# DEPARTMENT OF HEALTH AND SOCIAL SERVICES ANCHORAGE PIONEER HOME – PHARMACY RELOCATION ANCHORAGE, AK

### **ADDENDUM NO. 2**

SUBJECT: Extend Bid Deadline and Bidder Questions

Project # AJF 19-03C

Drawing No. E102

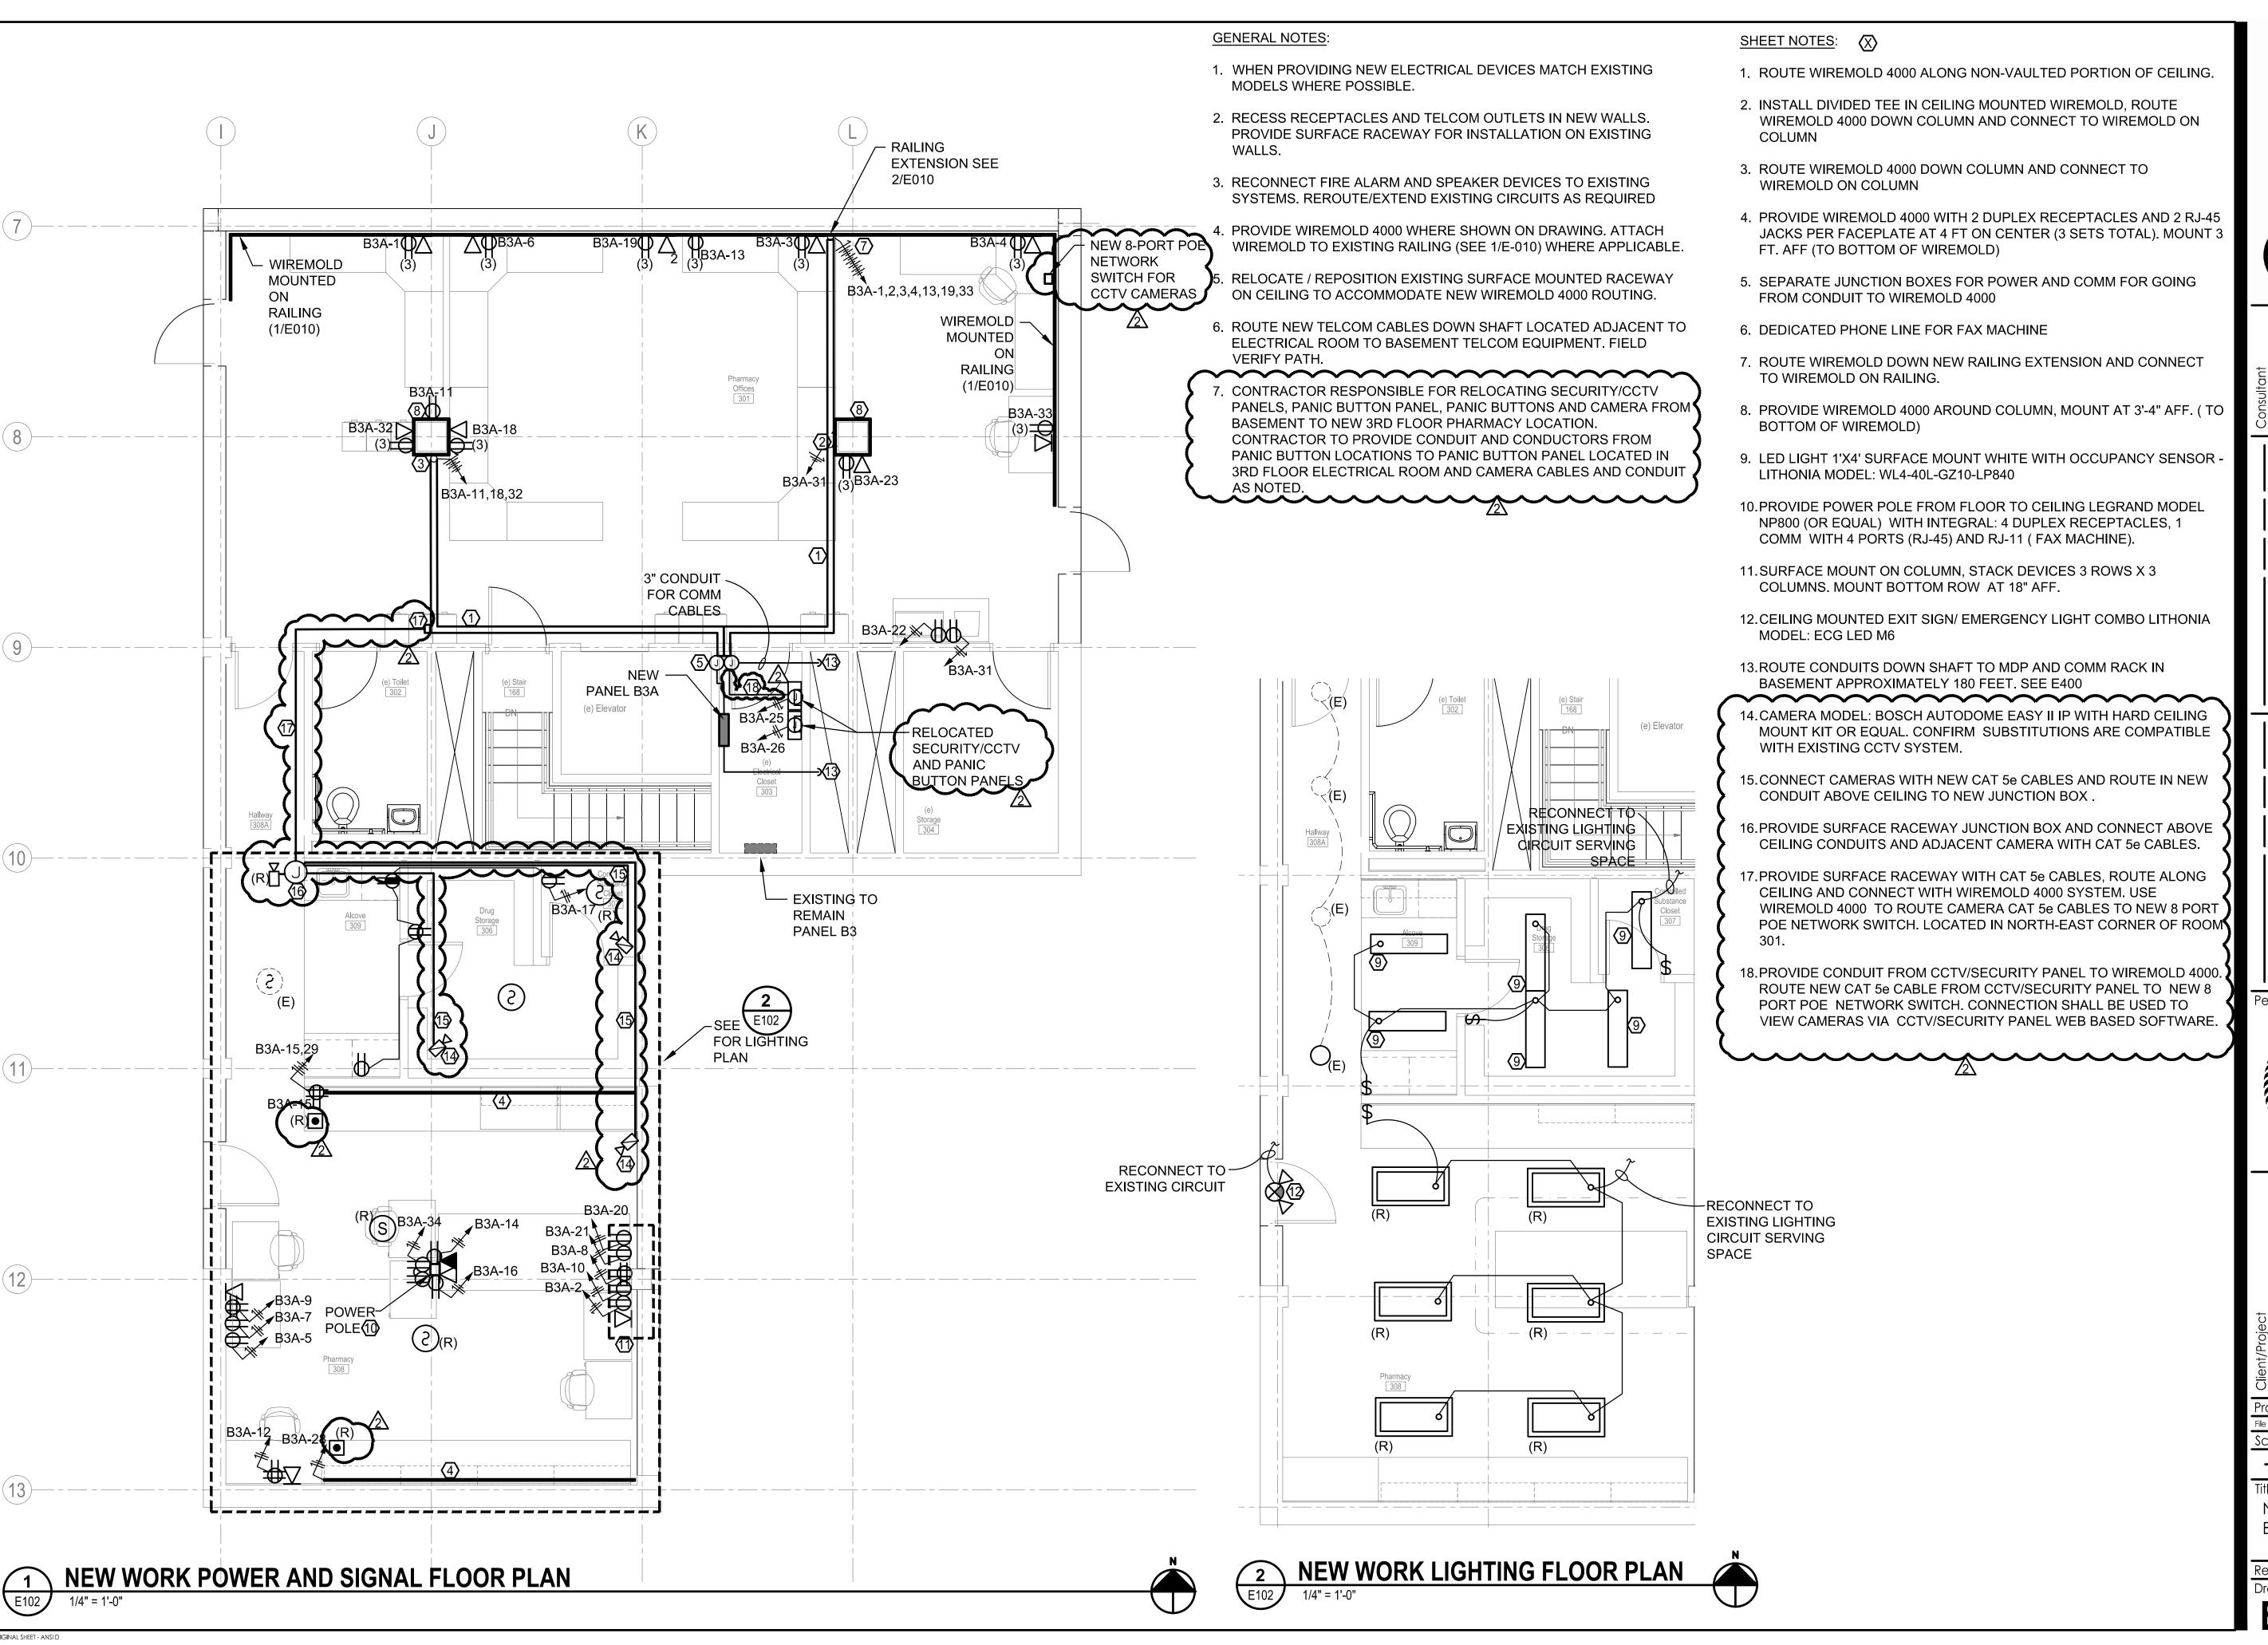
BIDDER QUESTION	DESIGNER COMMENT	DOCUMENT REFERENCE
Are security cameras included in the bid?	Security cameras are included in the scope of work. Provide (2) new and (1) relocated camera. See details and information on updated sheet E-102.	E-102
